Memorandum

To: Boulder County
From: Max Rusch, PE, PTOE, RSP1
Date: November 6, 2025
Re: CEMEX Longmont Lyons Plant – Traffic Study Evaluation

Figure 1: Historical Clinker Production and Daily Truck Volumes

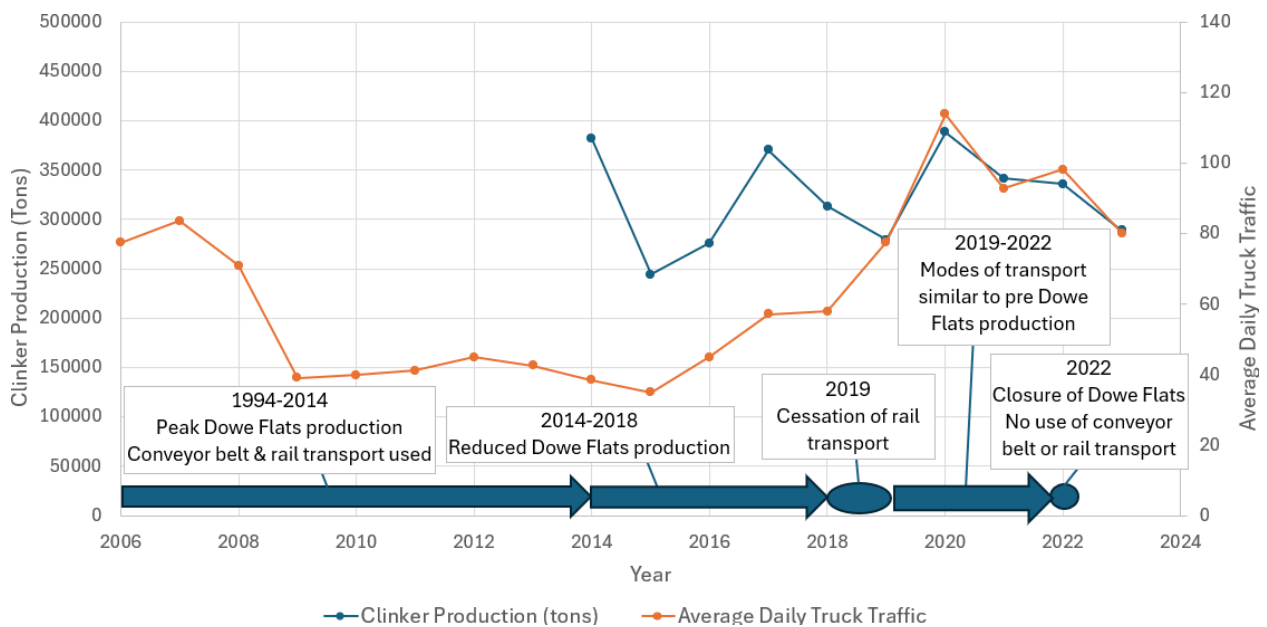
As is clear from the figure, daily truck traffic between 2014 and 2018 was relatively low compared to clinker production, with a noticeable upward trend beginning in 2015. From 2018 to 2019, truck traffic increased significantly relative to the clinker production and then continued to mirror the clinker production in subsequent years. This indicates that as other modes of material transport were phased out beginning in 2014, with the rail transport stopping entirely after 2018, truck traffic increased relative to the clinker production. Although truck traffic was

much higher during the 2019–2023 period than in the 2014-2018 period, clinker production levels remained relatively constant. When comparing the annual averages between the 2014-2018 period and the 2019-2022 period, it was found that the average annual clinker production increased by 6% (318,012 tons per year to 336,379 tons per year) while the annual truck volume increased by 118% (10,992 trucks per year to 23,974 trucks per year).

The methodology in comparing the “before” 2019-2022 to the “after” 2023 conditions is flawed. As can be seen in the volume trends from the figure in the executive summary, by 2019, the rail line was no longer exporting material from the CEMEX plant, and the conveyor belt that imported raw materials from the Dowe Flats Quarry had slowed production. This study should have used 2014-2018 as the “before” conditions to accurately assess the impacts that the closure of the Dowe Flats Quarry had on truck traffic.
